218948

Appendix A – Response to Submissions

Extracts from Government agency and authority submissions and submissions from the general public received in relation to SSD 10342, and a response to each of these matters, has been provided in the sections below.

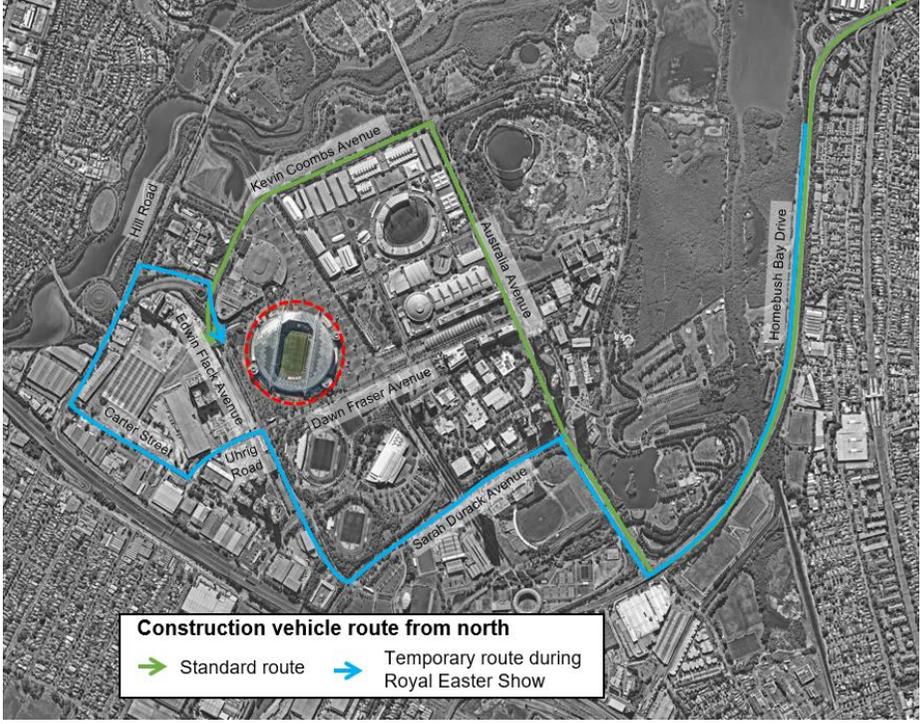
No.	Extract	Comment
DPIE6	<ul style="list-style-type: none"> Provide a copy of the current Stadium Events Management Plan. 	<p>An Event Management Plan is to be prepared following the detailed design and construction of the stadium, and formalised and implemented for the operation of the stadium, as detailed in Mitigation Measure D/O-SEC7.</p>
DPIE7	<ul style="list-style-type: none"> Provide a revised Noise and Vibration Assessment confirming existing and proposed noise levels during concert/sporting events (Table 26) and addressing matters raised by the Environment Protection Authority. 	<p>Each of the matters raised by the NSW EPA are addressed in Section 1.3 below.</p>
DPIE8	<ul style="list-style-type: none"> Provide further information regarding proposed construction traffic routes during the Royal Easter Show when various road closures are in effect. 	<p>The Transport Impact Assessment prepared by JMT and submitted as Appendix S of the EIS confirms that Olympic Boulevard will not be used for construction vehicle access or egress so as not to impact other activities in Sydney Olympic Park such as the Royal Easter Show or events at Qudos Bank Arena. This enables the Plaza and Aquatic bus terminals to remain open during the Royal Easter Show. All major event buses that currently access Sydney Olympic Park will still have the ability to do so during the construction works.</p> <p>During the Royal Easter Show only one construction vehicle route will be impacted due to road closures that are implemented – that being vehicles arriving from the north and travelling along Kevin Coombs Avenue. During the Royal Easter Show a section of Kevin Coombs Avenue is closed to vehicle traffic. Therefore, the temporary construction route will involve vehicles using Australia Avenue and Sarah Durack Avenue to access the construction site, as shown in the figure below.</p>

No.	Extract	Comment
		 <p>Construction vehicle route from north</p> <p>→ Standard route → Temporary route during Royal Easter Show</p> <p>All other construction vehicle routes arrive/depart to the south and west of the site via Uhrig Road, Carter Street and Hill Road which are not subject to temporary road closures during the Royal Easter Show.</p>
DPIE9	<ul style="list-style-type: none"> Provide further information regarding the potential impact of the proposed construction compound on pedestrian routes during the Royal Easter Show. 	<p>No works are identified in the surrounding road network or footpaths, or that would extend beyond the nominated construction compound. As such, the proposed construction works will not impact existing pedestrian and cycle routes or public transport services. The Transport Impact Assessment (Appendix S of the EIS) further confirms that no footpath closures will be required to facilitate the construction project as the proposed construction compound boundary is entirely within the public domain surrounding the stadium and does not extend onto the surrounding footpath or road frontage.</p> <p>As noted in the Transport Impact Assessment, a construction site boundary will be established which does not impact pedestrian movements to/from Qudos Bank Arena, the Royal Easter Show and more generally along Olympic Boulevard. This construction site boundary will be developed in consultation with SOPA to ensure there is sufficient capacity for pedestrian movements during these events.</p>
